UNITED STATES PATENT AND TRADEMARK OFFICE

APPLICATION NO.	FILING DATE	FIRST NAMED INVENTOR	ATTORNEY DOCKET NO.	CONFIRMATION NO.
10/633,343	08/01/2003	Peter A. Burke	ST8635US	3733

Office Action Summary

Claim Rejections - 35 USC § 103

Fig. 6.

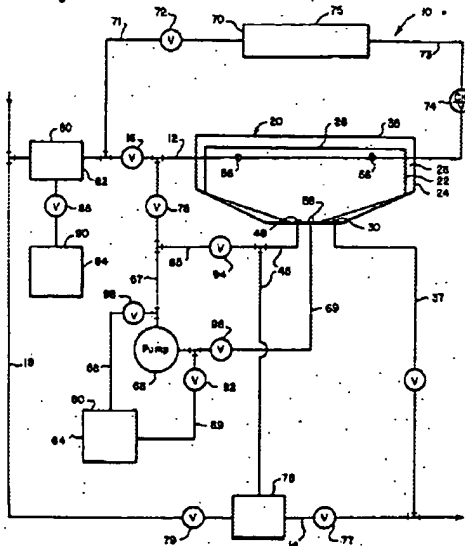
Sundheimer teaches an endoscope reprocessor 10 having a circulation system 67,69, 48, 71,73, a chamber 22, and a water filtration system 75. The reprocessing system of

Sundheimer includes a bypass line 12 wherein fluid can bypass the filter system 75. Sundheimer discloses that the water filtration system 75 "includes a series of filters" and "can be any commercially available filters which remove medically undesirable microbes" (col.4, lines 45-49), but does not teach that the filtration system includes first and

second filters wherein the second filter is downstream of the first filter and has the capacity to filter particles smaller than the first filter.

Pall et al teaches a filter system comprised of a first filter having an absolute pore rating of about 0.1 to about 1.0 μm and a second downstream filter having an absolute pore rating of about 0.02 to about 0.1 μm . The filter system is effective in removing bacteria and endotoxins and can be employed in the form of a single filter cartridge or two separate filter cartridges used in a series arrangement. See Abstract; col.11, lines 42-47; col.16, line 64 to col.15, line 6. As the filter system of Pall is effective in providing medical grade water, it would have been obvious to use as the filter system of 75.
